Land to the East of Longwater Road, Finchampstead

LVA Addendum

edp4070_r016b

- 1.2 This Addendum has been prepared following the objection to planning application reference: 241567 from the Landscape and Tree Officer (LTO) at Wokingham Borough Local Planning Authority (LPA), and shows how the Reasons for Objection (RfO) have been addressed by the previously submitted LVA and where necessary, the revised layout, which has been submitted for consideration.

Image EDP 4.1: Aerial overview of the site in the context of Finchampstead and surrounding settlements. The expansive MGLCP forms a large buffer between the settlements, as well as the sewage works and surrounding vegetation associated with the river

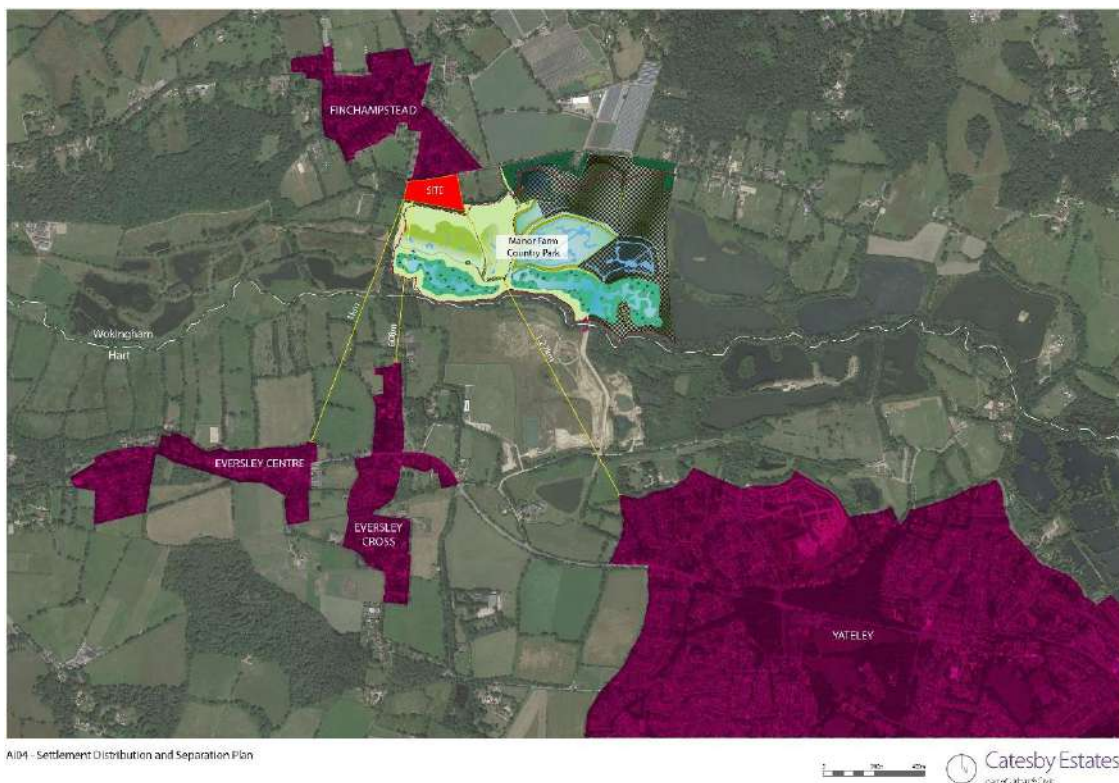
3. *“The site contributes to a sense of separation between the settlements of Finchampstead and Eversley Cross to the south.”*

- 4.13 The site provides a limited contribution to the sense of separation between Finchampstead and Eversley Cross to the south. As evidenced in the LVA, there is no intervisibility between the site and Eversley Cross. The southern boundary of the site borders the evolving Moor Green Lakes Country Park (MGLCP), which is a primary source of separation between the settlements, and the presence of the Country Park will result in a permanent nature buffer between Finchampstead and Eversley Cross, as well as the sewage works and vegetation associated with the River to the south (see **Image EDP 4.1**).

- 4.14 Users of Longwater Road currently experience a sense of leaving Finchampstead leading to undeveloped countryside, before entering Eversley Cross. The proposed development and access abuts the settlement edge, minimising the extension of Finchampstead and maintaining a sense of leaving settlement and separation along this section of the road. Therefore, development of the site would not result in a reduction of the sense of separation for Finchampstead and Eversley Cross, and no further assessment of potential coalescence impacts are required.

Appendix EDP 1
Site Layout
(CATE230603_SL01_A4)

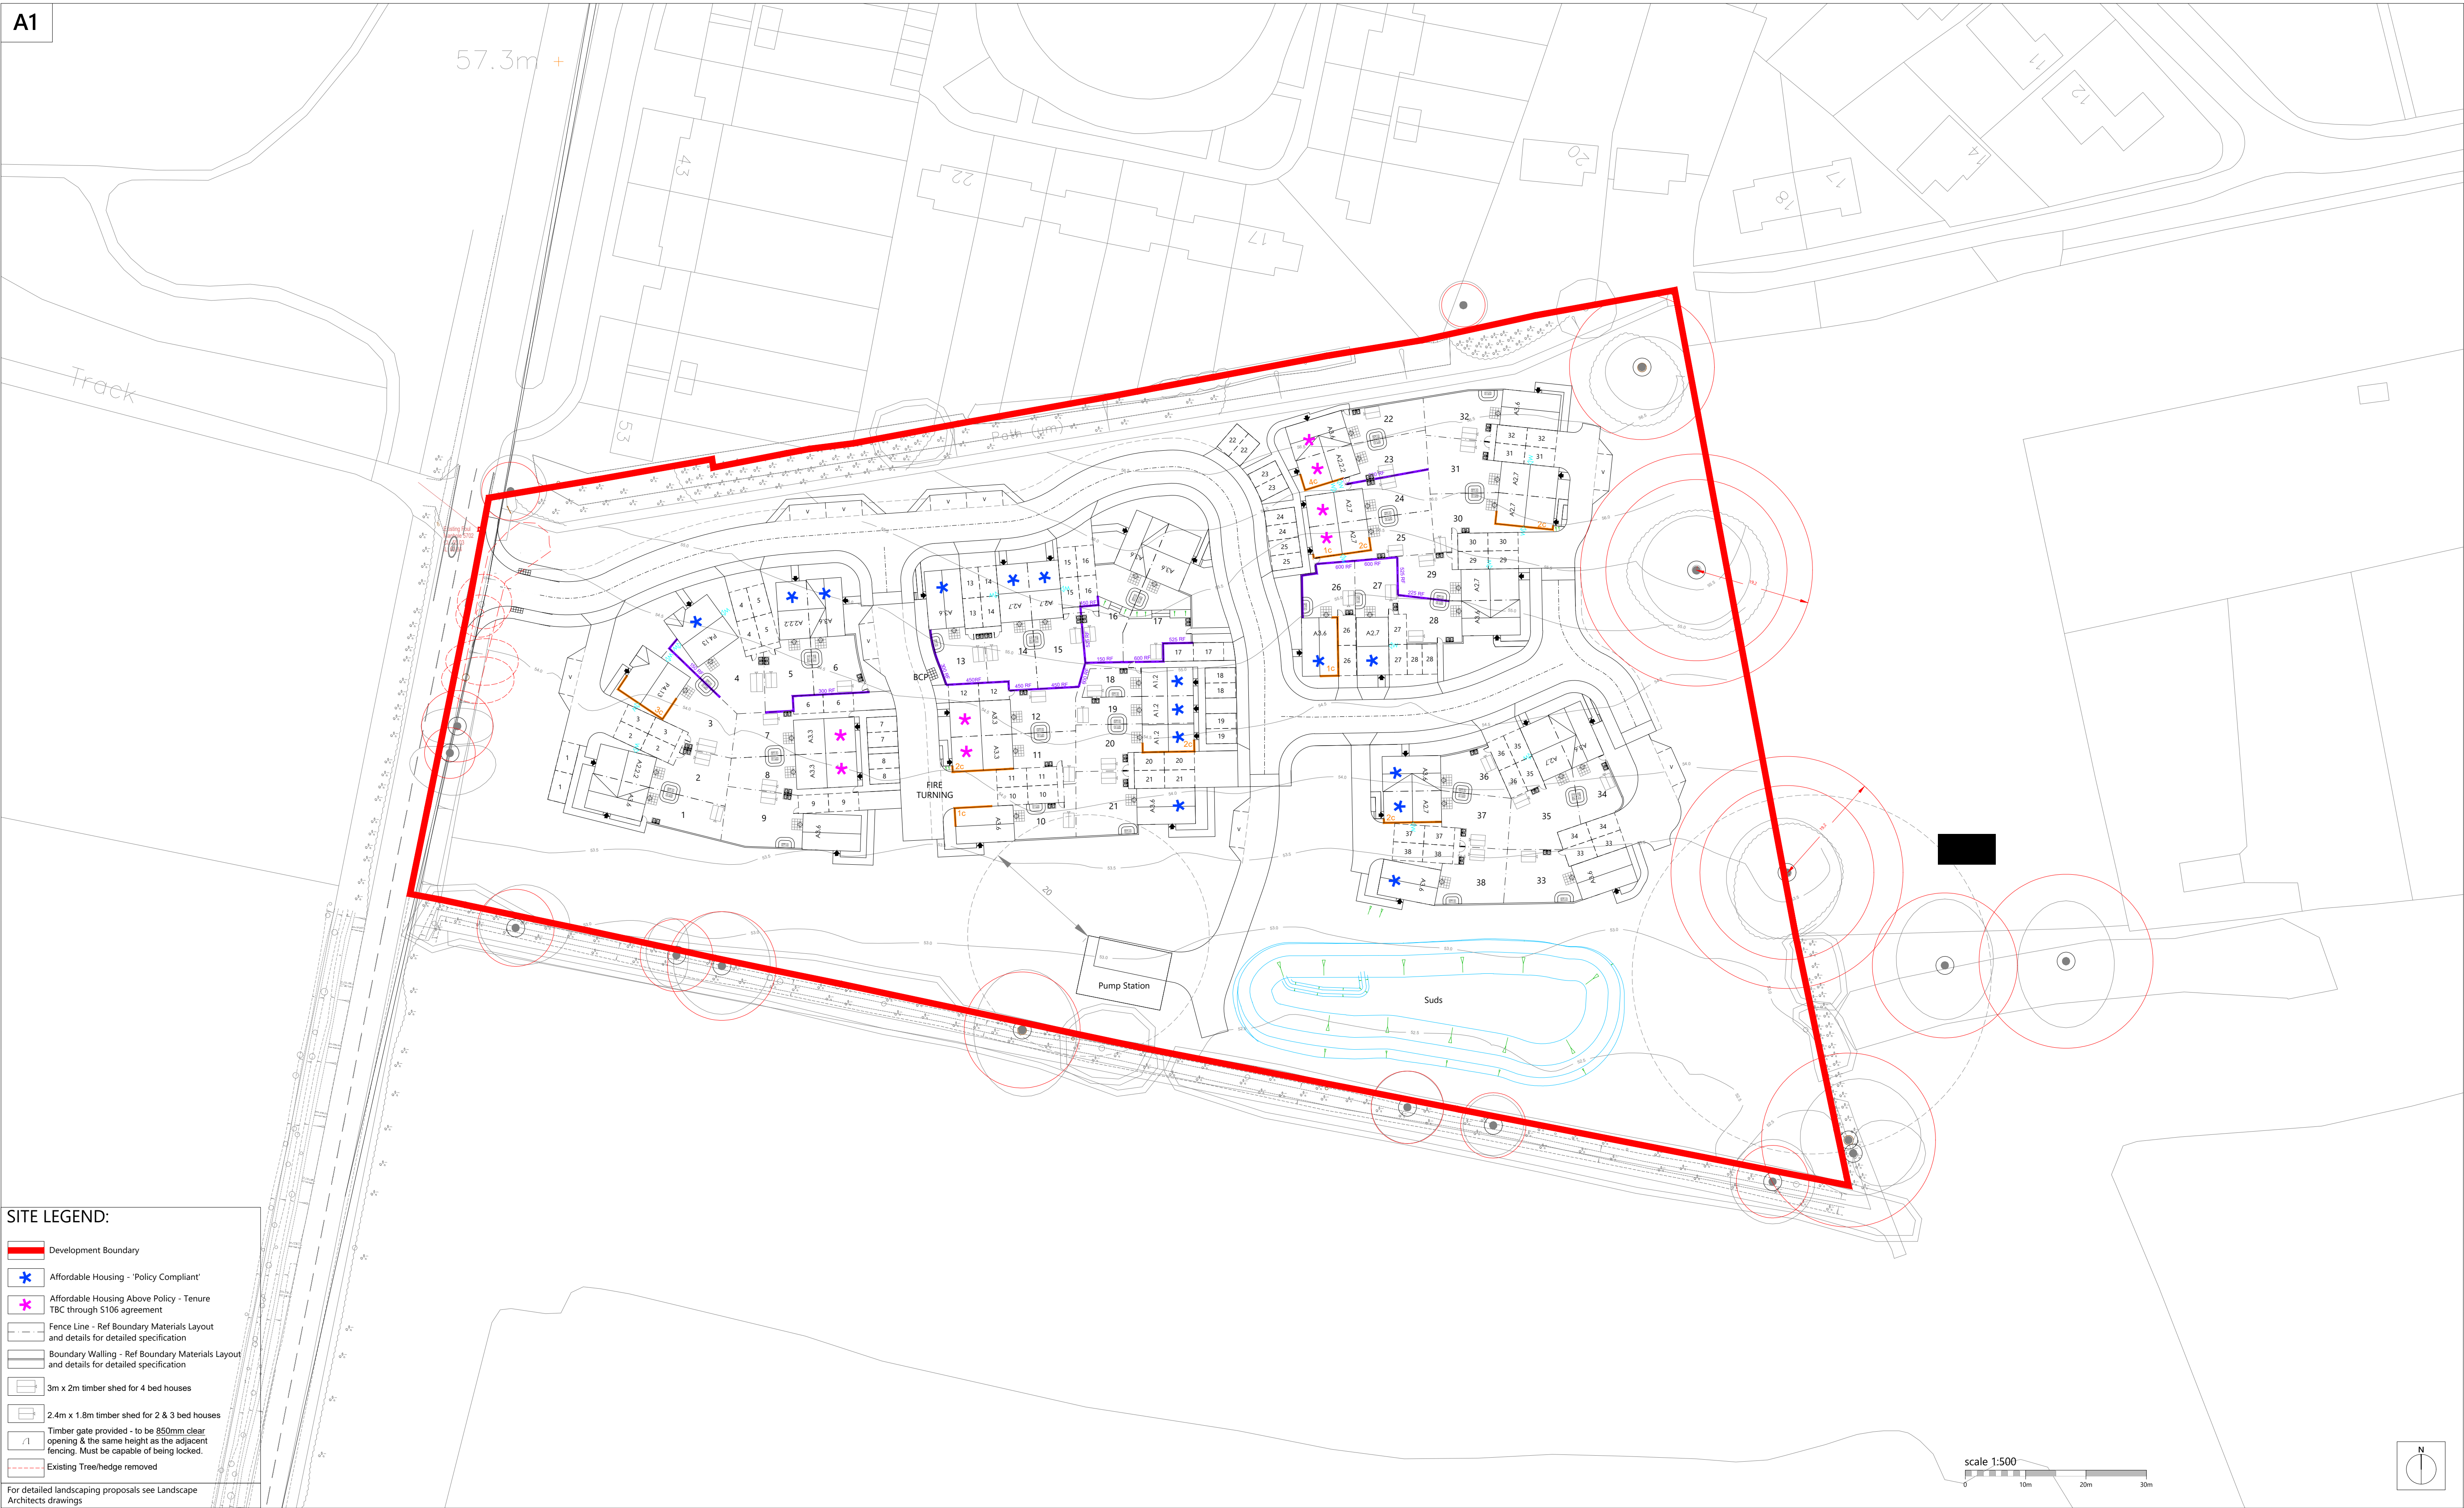
2. *“The housing layout uses a significant area of the site laid to built form around a loop form with a stem to the east, which represents an incursion into the buffer zone for the Veteran trees (T2 and T5).”*

8. *“The form of the layout is dominated by a large proportion of hard landscape, with unnecessary footpaths.”*
9. *“A softer approach to hard landscape materiality needs to be factored in to suit the character of the space.”*

13. *“The proposed layout of the development fails to integrate/successfully extend the built form of southern edge of Finchampstead village. The design does not relate back to the landscape character and what we would expect to see.”*

- 4.25 The updated layout has removed the loop form, and reduced the amount of adoptable road. The use of private roads reduces the overall widths and infrastructure inputs required for these sections; in particular, the roads leading north/south have been deliberately designed to be shared surfaces with a varied surface material (and narrower than the main road) to help provide a more rural feel as you transition towards the more sensitive southern edge of the development. All development has also been moved so that it is located outside of the extended buffer zones requested for tree T2 and T5 (**Appendix EDP 1**).

4.30 The extent of footpaths have been reduced across the site, with particular focus on the reduction of footpaths on the outer edges of the development (**Appendix EDP 1**). More incidental spaces have been created internally to allow for tree and shrub planting within the scheme, to break up the hardscape and connect with the periphery landscape (**Appendix EDP 3**).

- 4.34 The updated layout has moved built form north and altered some of its orientation to create a stronger link with the existing settlement, whilst retaining the existing movement corridor along the northern boundary and maintaining a suitable distance from existing dwellings for privacy and placemaking reasons (**Appendix EDP 1**).

Green Link

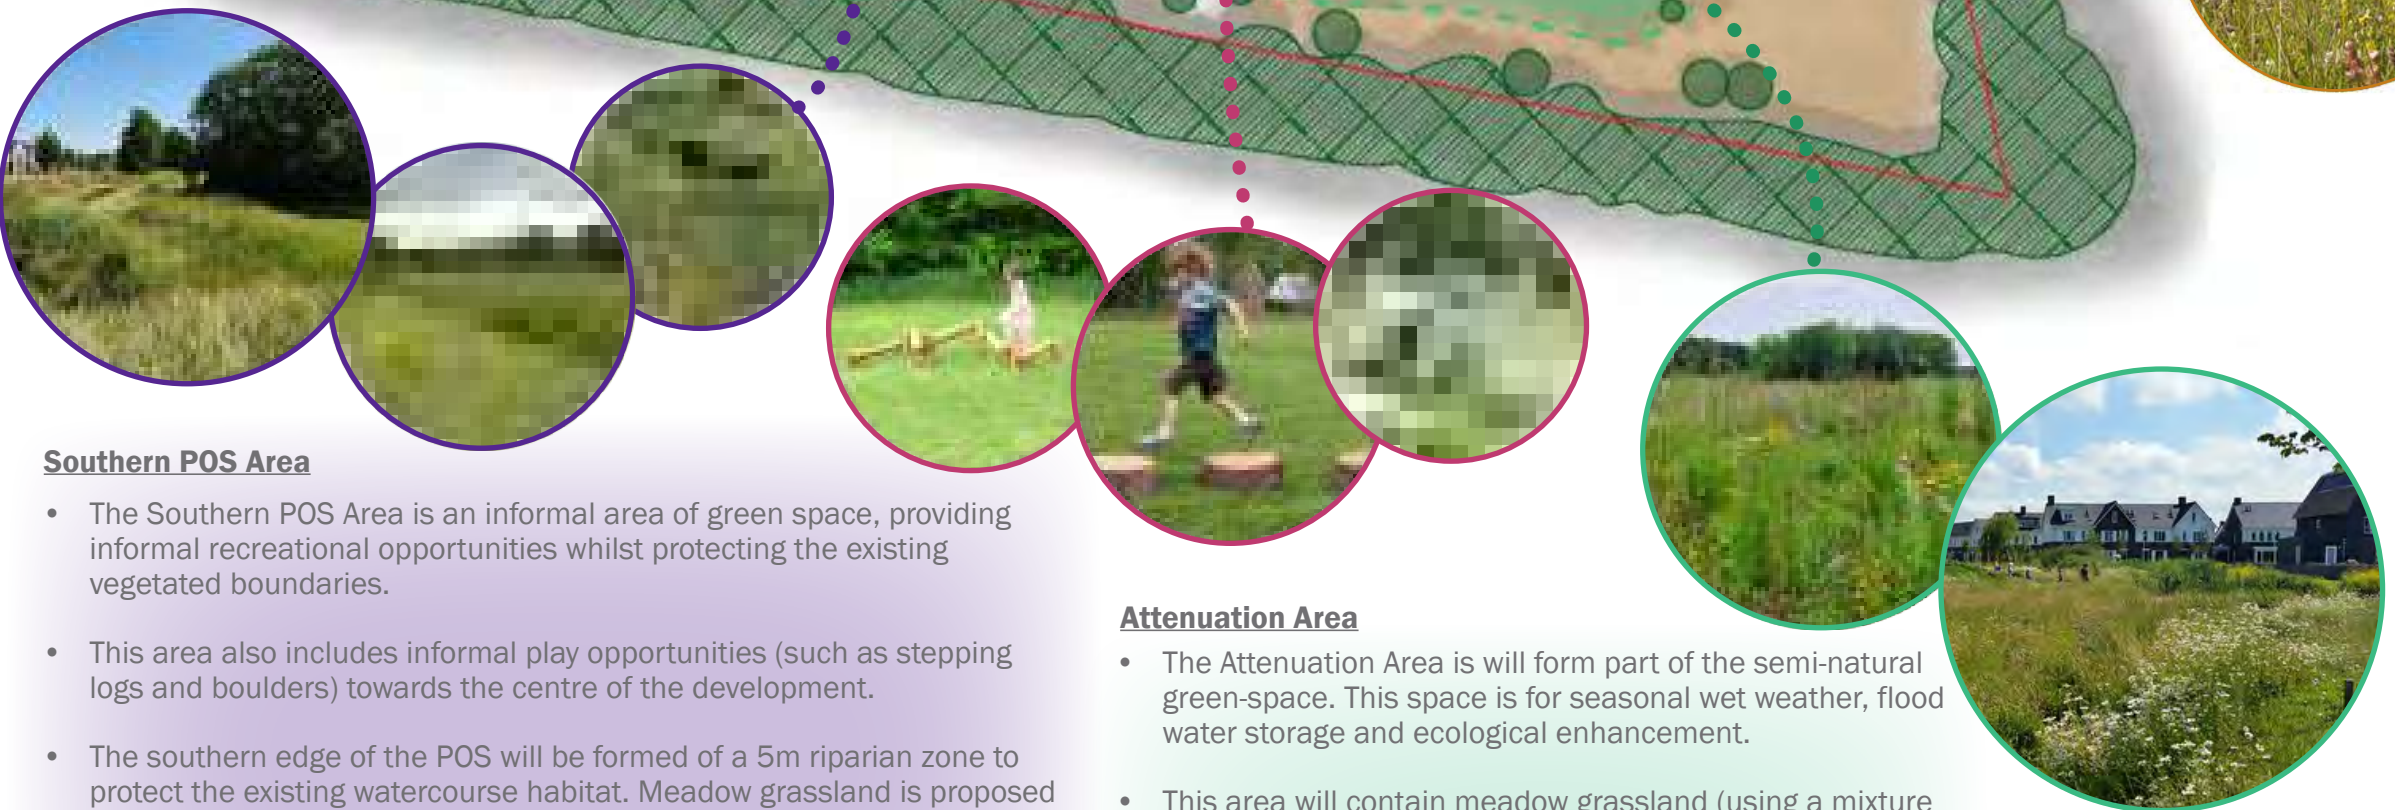
4. *“The PROW that traverses the site is a direct link to the Country Park. A link is proposed within the site but is this really necessary?”*

- The Green Link Area is defined as a gateway green-space that will integrate the existing PRoW and soften impacts on adjacent receptors.
- Existing bramble scrub will be retained with the introduction of native mixed scrub to diversify the habitat and enhance the buffer to neighbouring gardens. Amenity grass is proposed along the footpath to maintain a sense of openness.
- Structural tree and hedgerow planting will provide a layered approach to landscaping, softening views of the development as users of the PRoW pass through the site.
